Oil Filter Replacement

1.4L 4 cylinder engines (RPO: LUV)

Important: These engines are affected by an oil filter and filter housing cap supplier change mid-production. It is critical to confirm the correct oil filter is being used, otherwise the oil filter may be bypassed entirely. The VIN alone is not sufficient for oil filter application confirmation.

Identification

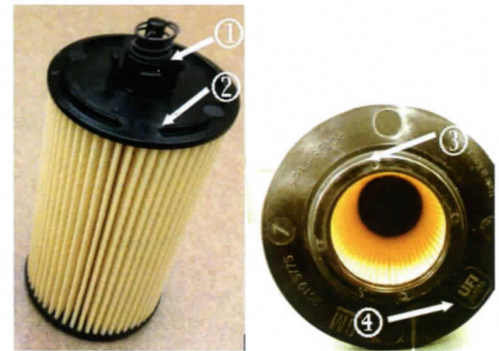
1. Bypass valve
2. Felt type for bottom plate
3. No ribs
4. Supplier Name: Hengst

In order for correct operation to occur there must be ONE bypass valve in use. For vehicles that do not have the bypass valve built into the housing, use the filter shown on the right.

1. Bypass valve
2. O-ring type for bottom plate
3. 4 X Ribs
4. Supplier Name: UFI

USE PF2257G

USE PF2263G
